# Product Change Notification

## 112427 - 00

**Change Notification #:** 112427 - 00  
**Change Title:** Intel® Server System R2308IP4LHPC  
PCN 112427-00, Product Design  
Update System Power Supply Bracket,  
Printed Board Assembly (PBA),  
BIOS/ME/BMC/FRUSDR Firmware,  
Standoff, and Package Regulatory Label with  
Perchlorate Statement  
**Date of Publication:** July 10, 2013

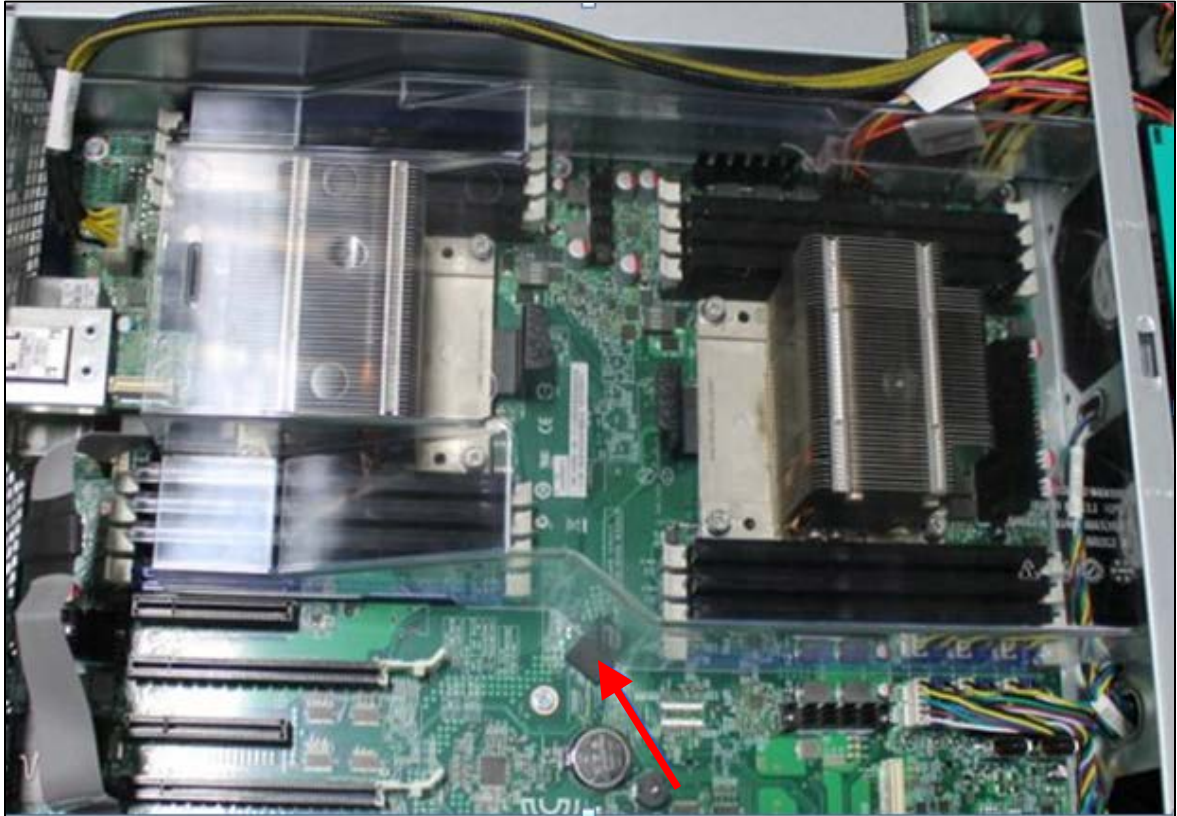
- 1) The server system chassis power supply bracket has been updated to add a cutout on the top side of the chassis to better fit the power supply module. Please refer to below picture for this change:

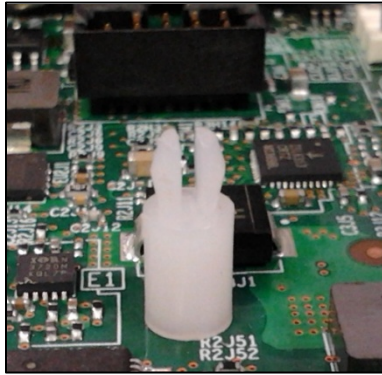
- 4) The Rail included in the system package will be updated from value rail kit AXXVRAIL to enhanced value rail kit AXXELVRAIL, the enhanced value rail kit Improved robustness over the value rail, same mechanical spec.
- 5) A plastic stand-off will be pre-installed on the server board. Users can install an eUSB SSD device on the stand-off.
  - a) The picture below shows what the stand-off looks like:
